Change Order #7 Dicker Road

Project: Dicker Road
Project #: STP 1902 (383) MM
Contract: C-19-017-11-05
CSJ: 0921-02-312
Limits: Spur 115 (23rd Street) to FM 2061 (Jackson Road)

Change Order #7 has been approved to make the following contract changes:

SHEET NO. 232a

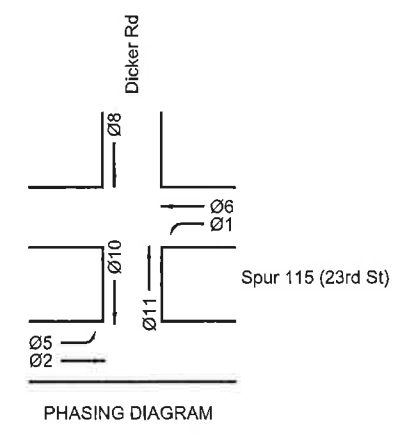
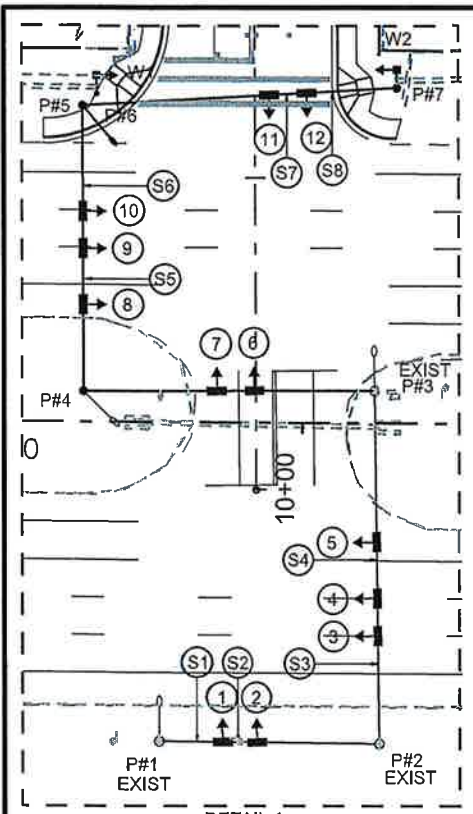
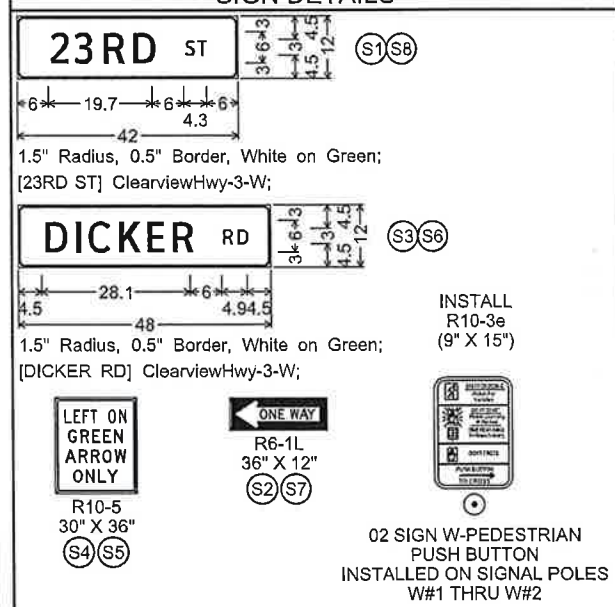
CO #7 - Change Order #7
Realign the North Median Signal Pole perpendicular to traffic on 23rd Street.

CO #7 - Change Order #7
Realign the North Median Signal Pole perpendicular to traffic on 23rd Street.

FED. RD. DIST. NO.	CONT.	SECT.	JOB	HIGHWAY	
06	0921	02	312	DICKER ROAD	
STATE	DIST.	COUNTY	PCT	CITY	SHEET NO.
TEXAS	PHR	HIDALGO	No 2	HIDALGO	171a

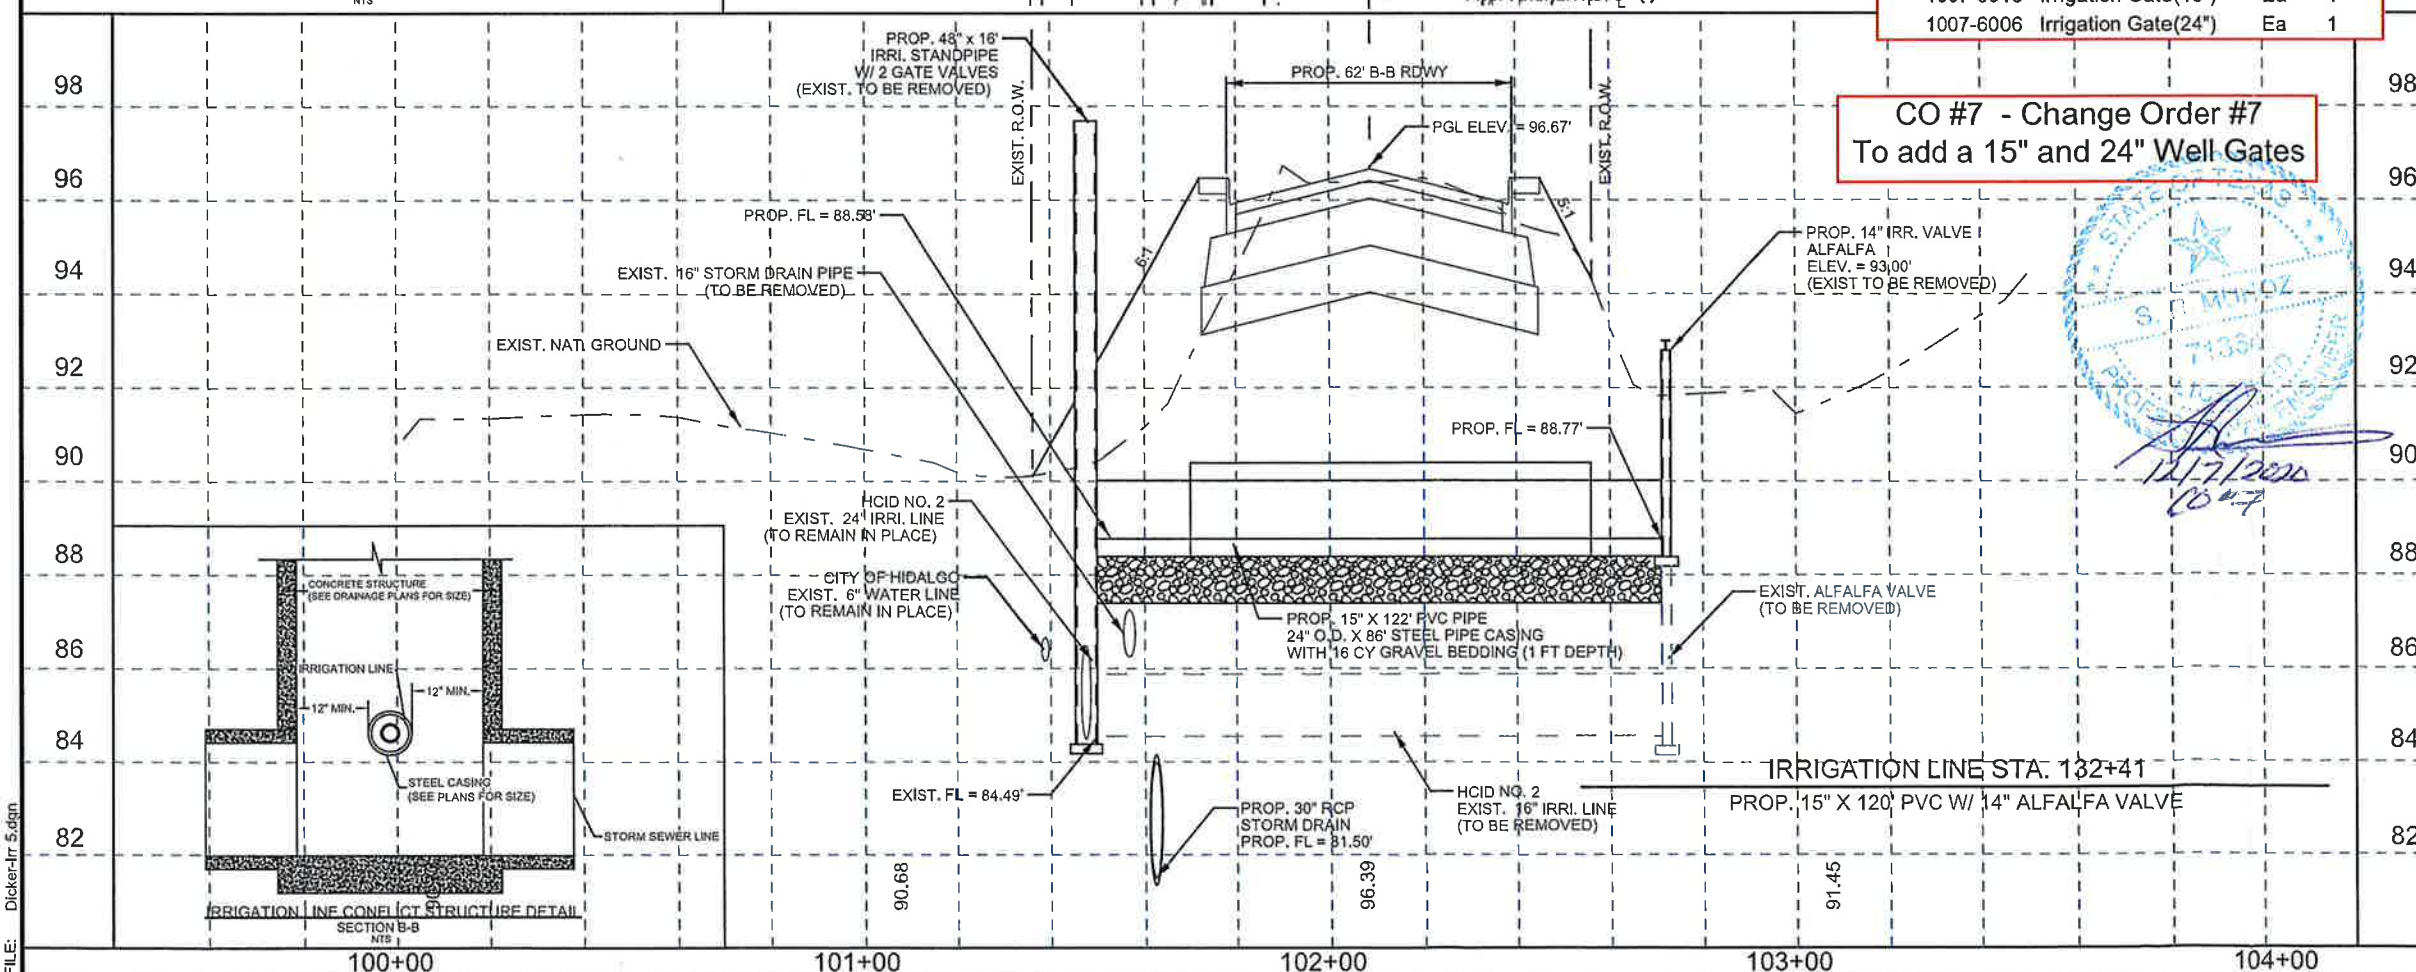
Add			
1007-6013	1007-6013	1007-6013 Irrigation Gate(15")	Ea 1
1007-6006	1007-6006	1007-6006 Irrigation Gate(24")	Ea 1

CO #7 - Change Order #7
 To add a 15" and 24" Well Gates

SHEET NO. 155a

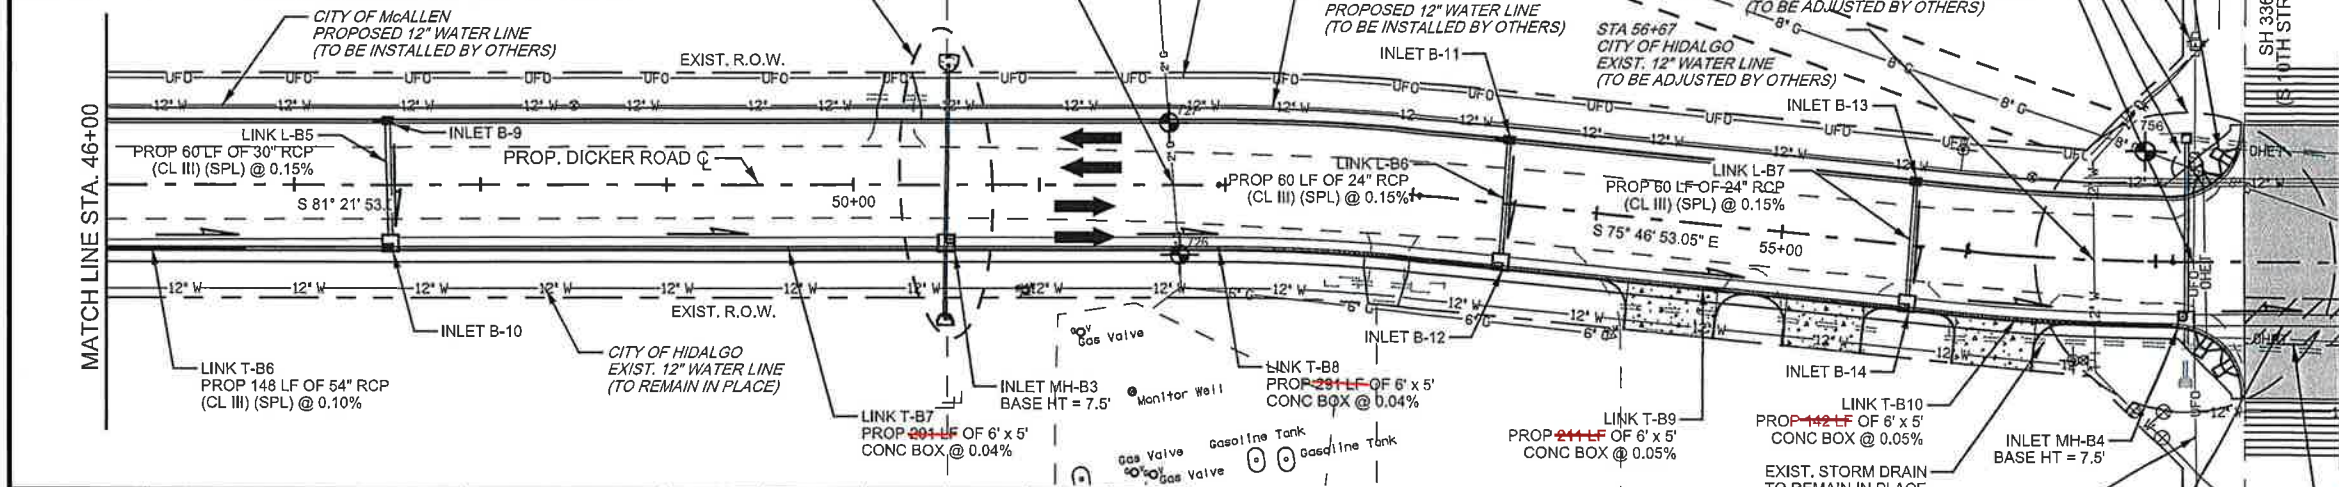
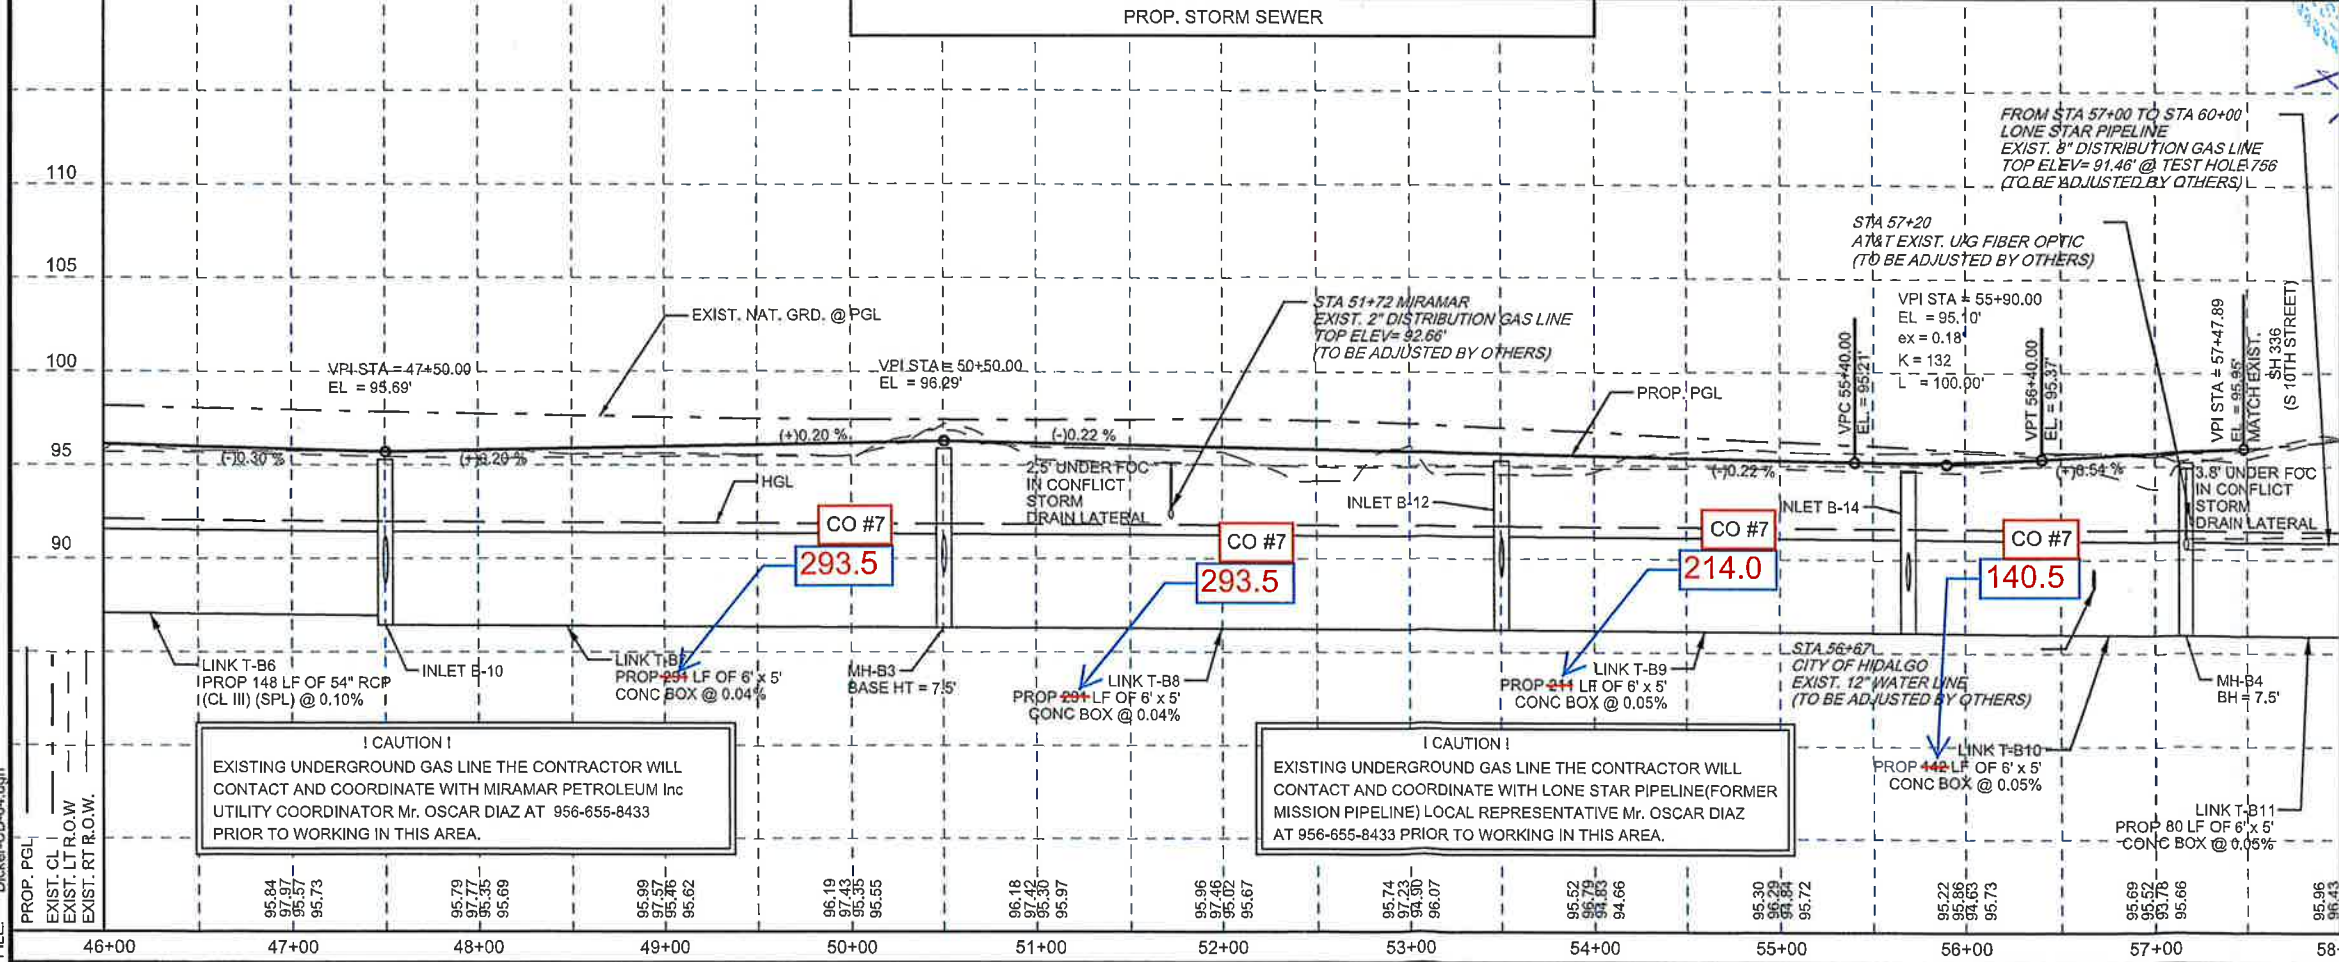
CO #7 - Change Order #7
 Adjust the 6x5RCB plan quantities to match field conditions

FED. RD DIV. NO.	CONT.	SECT.	JOB.	HIGHWAY	
06	0921	02	312	DICKER ROAD	
STATE	DIST.	COUNTY	PCT.	CITY	SHEET NO.
TEXAS	PHR	HIDALGO	No 2	HIDALGO	156a

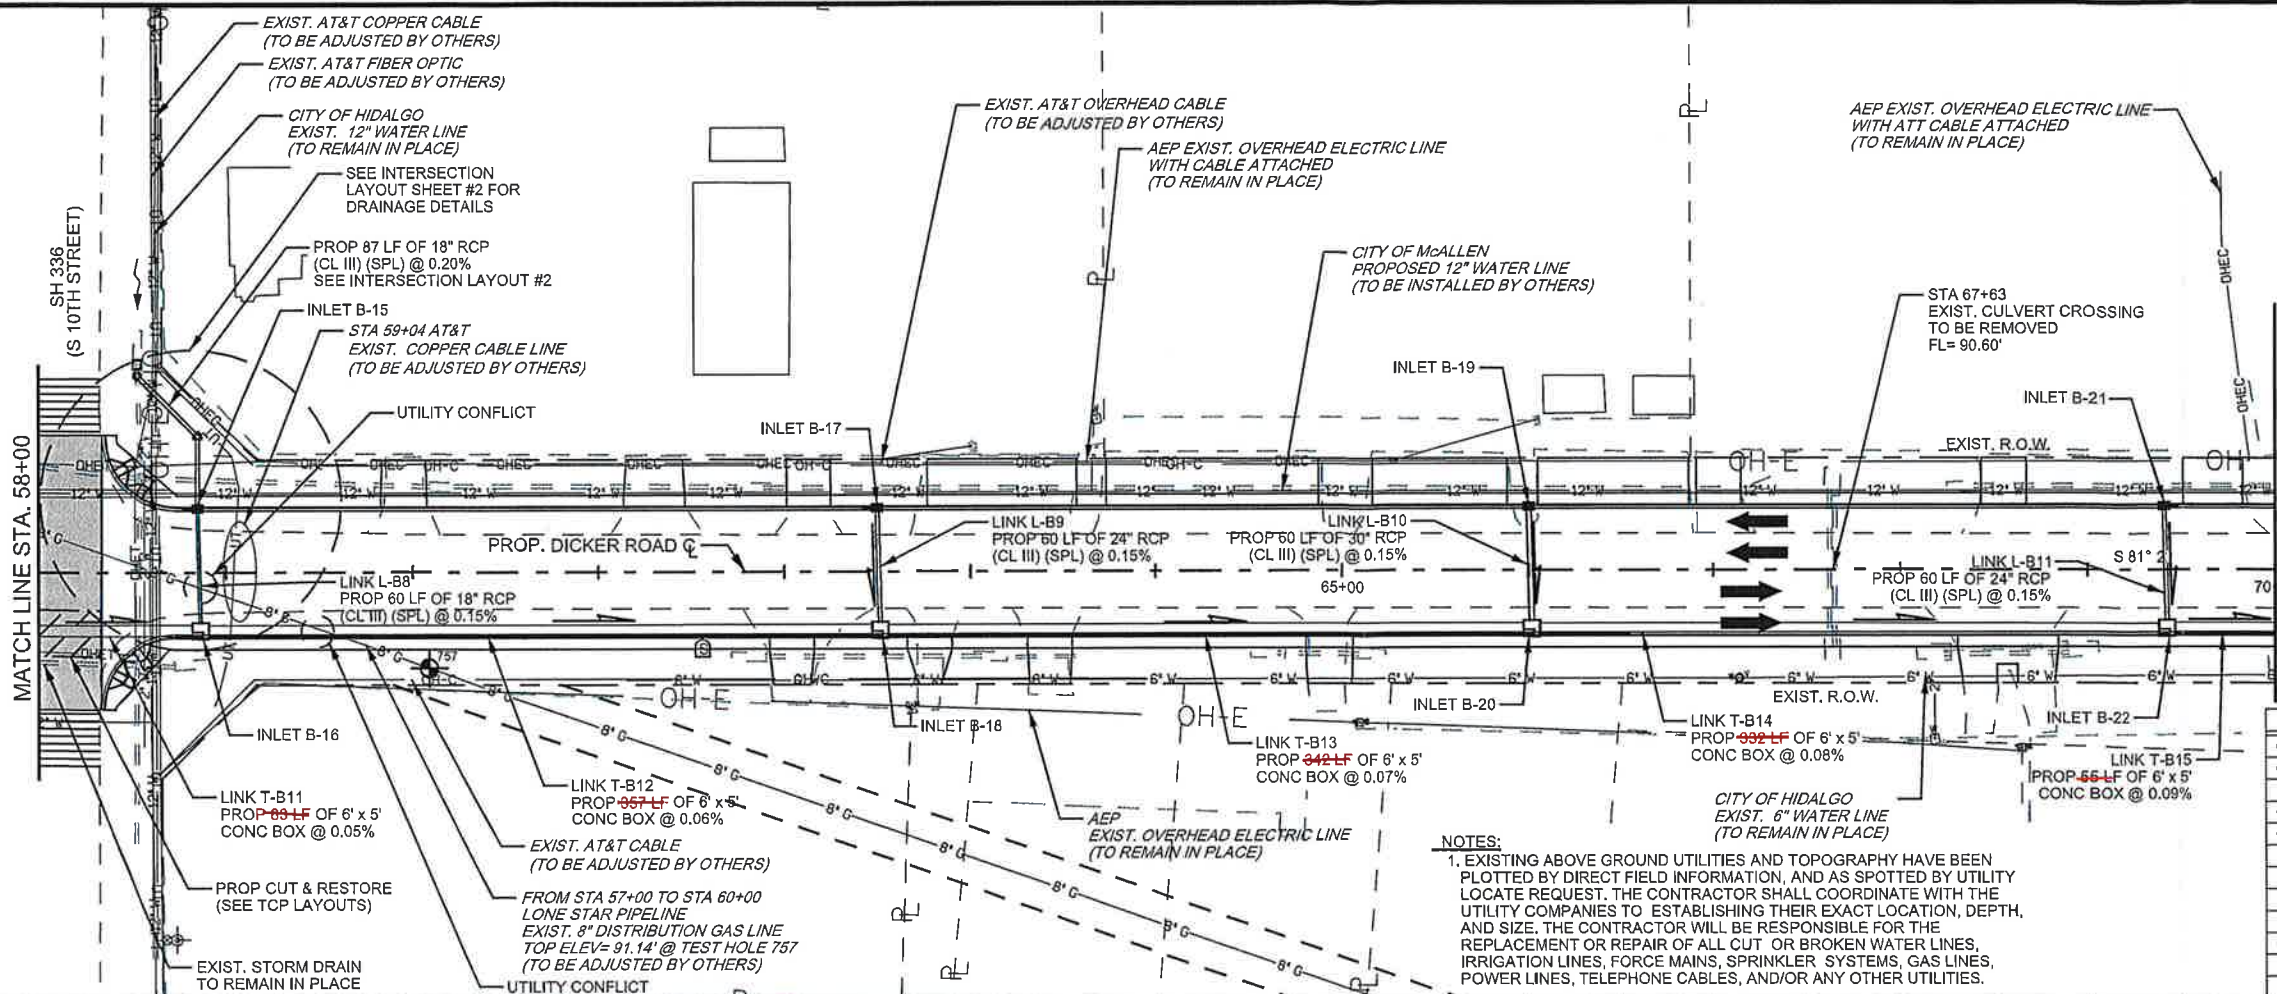
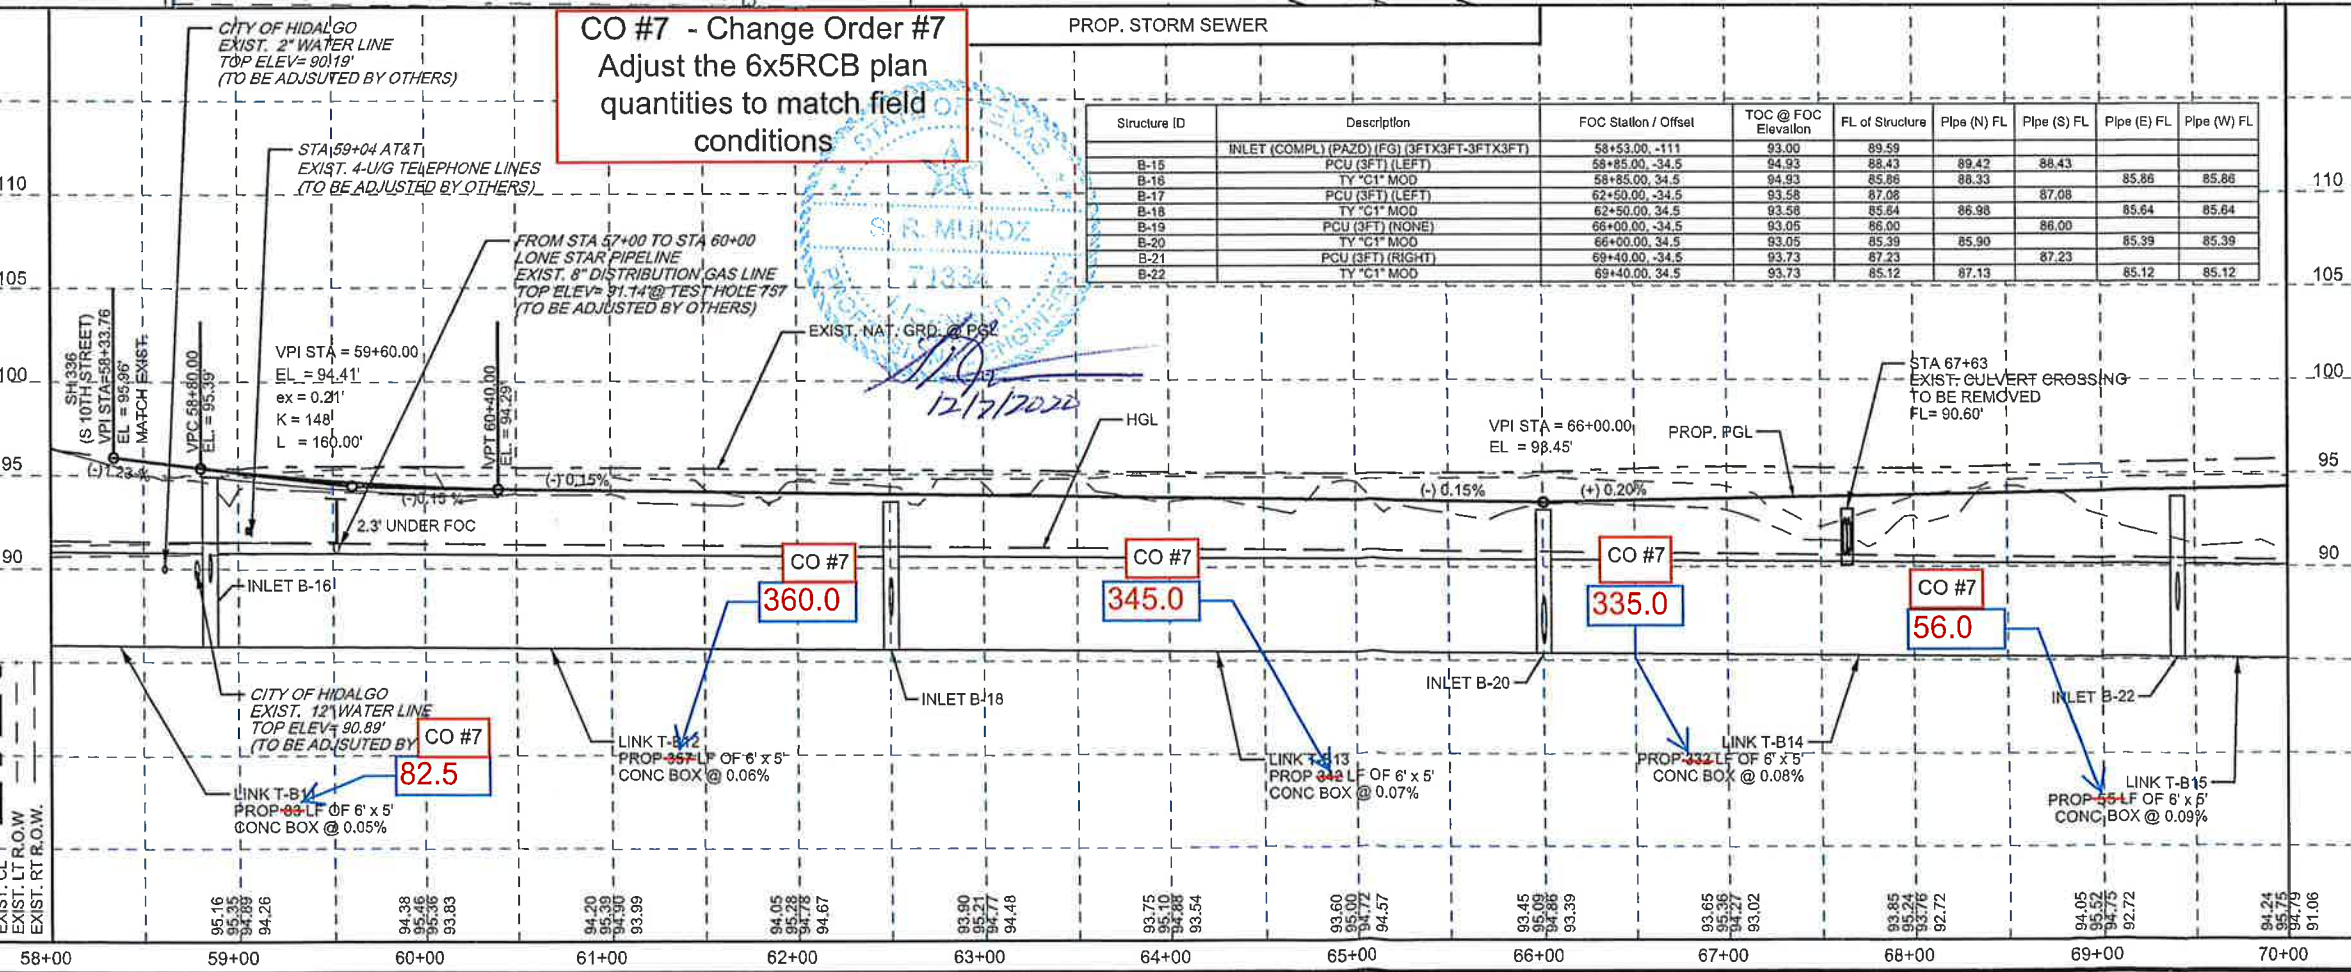
CO #7 - Change Order #7
Adjust the 6x5RCB plan quantities to match field conditions
